Official Transcript of Proceedings
NUCLEAR REGULATORY COMMISSION

Title: Advisory Committee on Reactor Safeguards
Power Uprates Subcommittee: Open Session

Date: Friday, February 24, 2012

In this meeting, the Subcommittee will review Turkey Point Power Units 3 and 4 License Request for Extended Power Uprate. We will hear presentations from the NRC staff and the representatives from the Applicant, Florida Power and Light Company.

Loss of load analysis results assuming higher initial pressurizer pressure confirms lower pressure is conservative

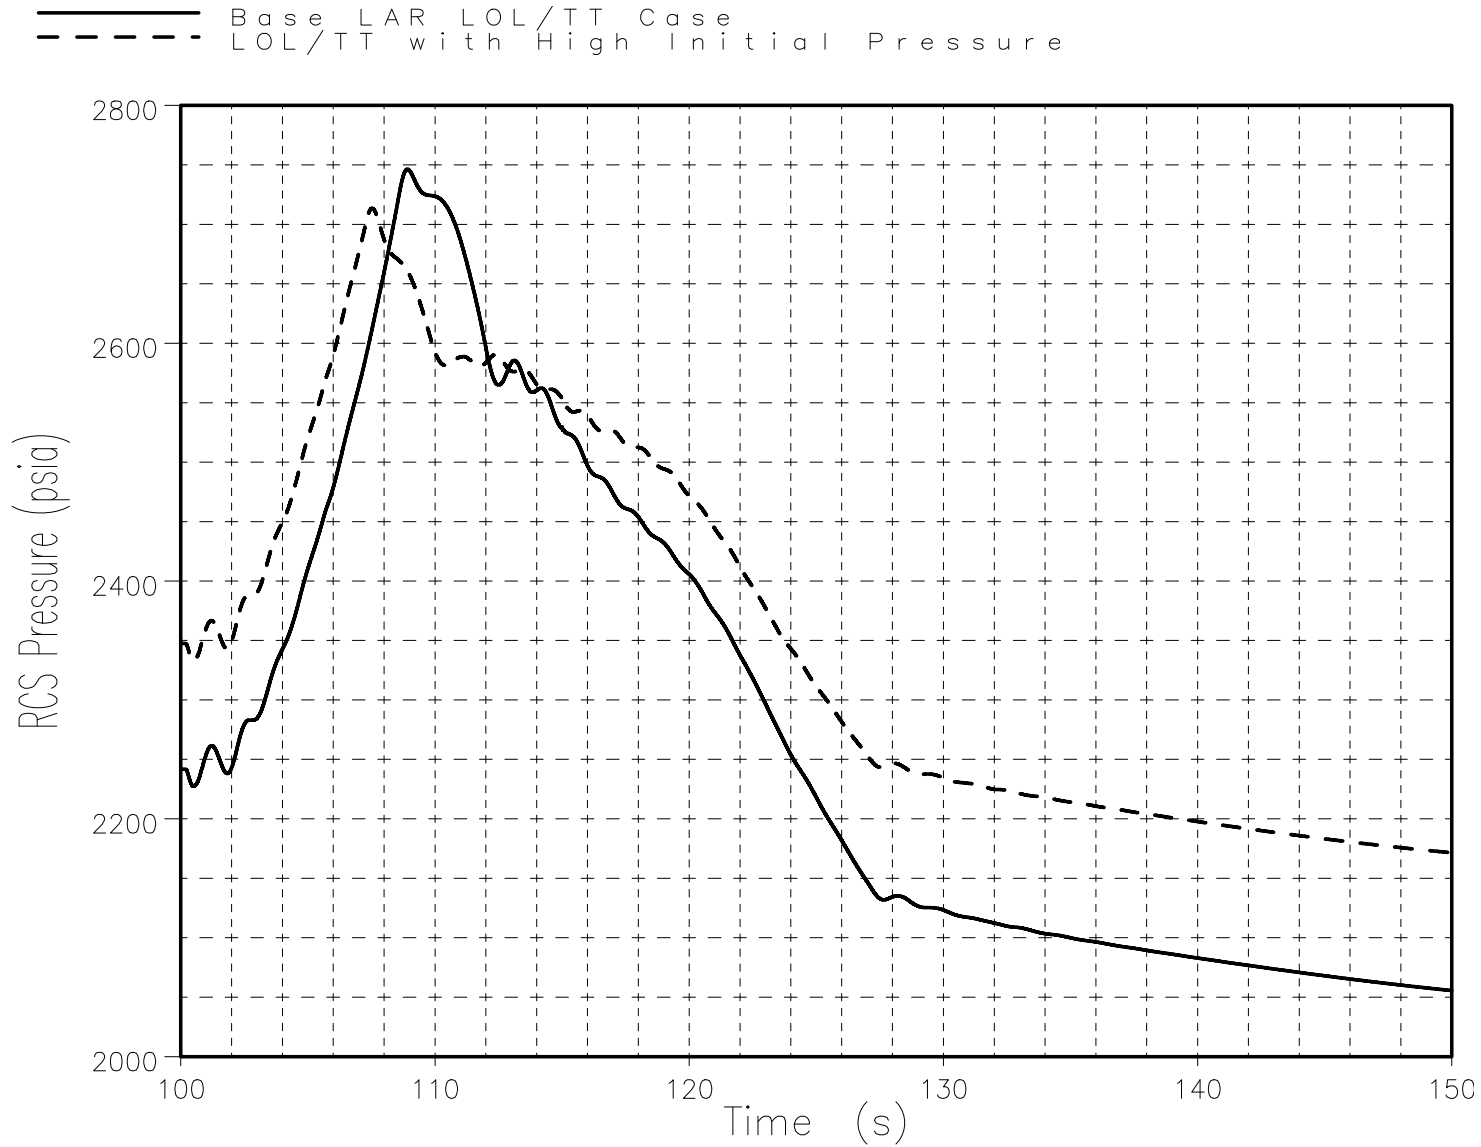
5 MR. HALE: You had a question regarding
6 the applying an uncertainty on pressure. We went with
7 a lower pressure versus a higher pressure uncertainty,
8 and intuitively you would think if you went with a
9 higher pressure that you would get a worse result. I
10 believe that was the genesis of the question.

- **Action Item – Perform loss of load analysis assuming nominal pressurizer pressure plus maximum pressure uncertainty vs. current analysis which assumes nominal pressurizer pressure minus maximum pressure uncertainty**

13 MR. HALE: What we did is we went back and
14 ran the case as you had requested, and, as expected,
15 the reason the higher pressure case is more
16 conservative -- is less conservative is you get a
17 earlier reactor trip.

19 MR. HALE: So that is the reason we go
20 with the lower pressure, because it maximizes the
21 pressure of the event.
